Subject: GRINDING NOISE FROM CLUTCH PEDAL WHEN DEPRESSING	Bulletin No: 05-003/16
	Last Issued: 02/10/2016

2016 MX-5 vehicles with VINs lower than JM1ND*****104047 (produced before August 7, 2015)

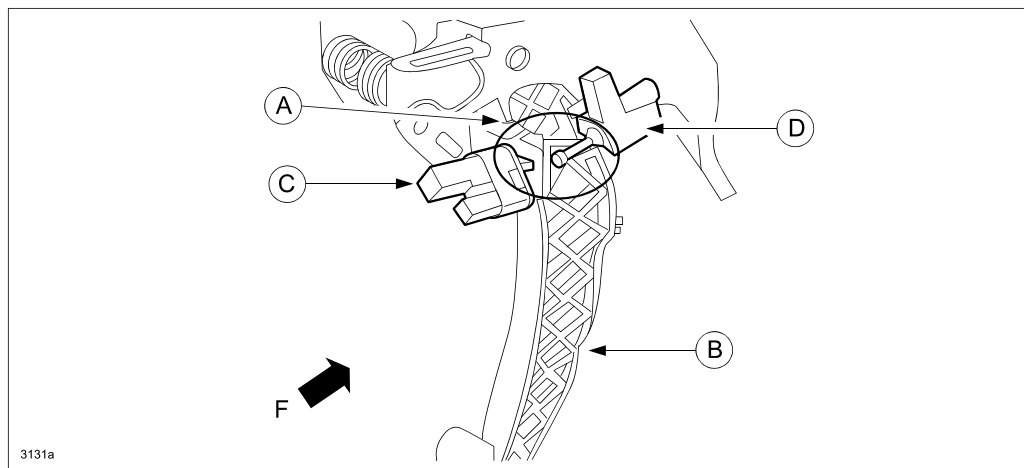
Some vehicles may exhibit a grind noise from around the clutch pedal when depressing it all the way down. This is caused by a stick-slip noise occurring at the contact point (A) between the clutch pedal (B) and the clutch pedal position switch (C) plunger and/or the clutch pedal and the starter interlock switch (D) plunger (F: Vehicle front).

To prevent the stick-slip noise from occurring, two pieces of silicon pad have been attached to the clutch pedal where the two switches contact.

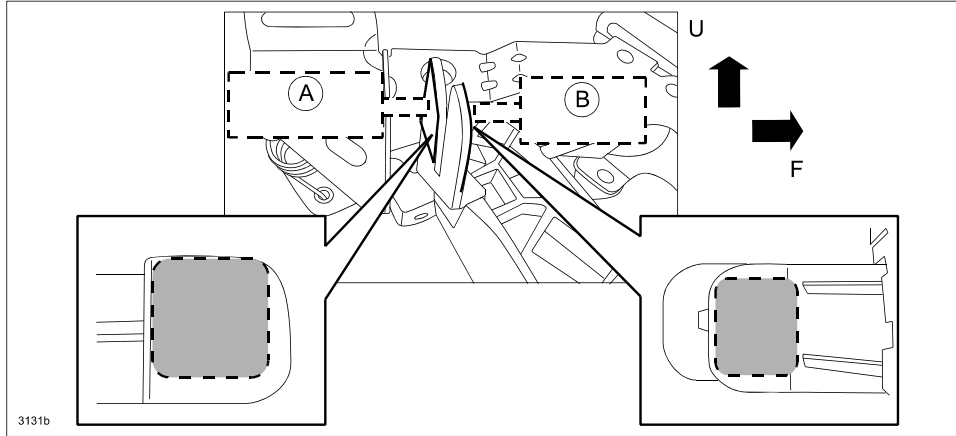
- b. Degrease the surfaces of the clutch pedal where the silicone pads will be applied for the clutch pedal position switch (A) and the starter interlock switch (B).

CLUTCH PEDAL POSITION SWITCH side

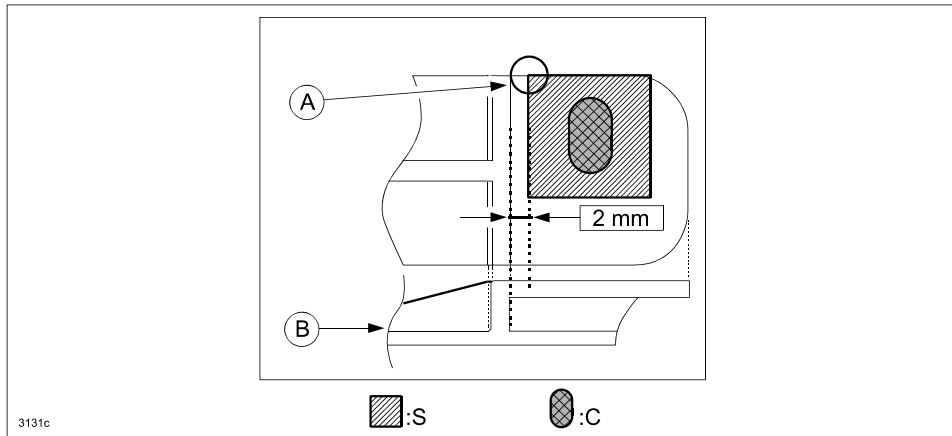
- c. Peel off the protective foil and apply the silicon pad to the clutch pedal as shown below (the clutch pedal position switch and the starter interlock switch sides).

A: Align one corner of the silicon pad with this point

C: Contact point of switch plunger
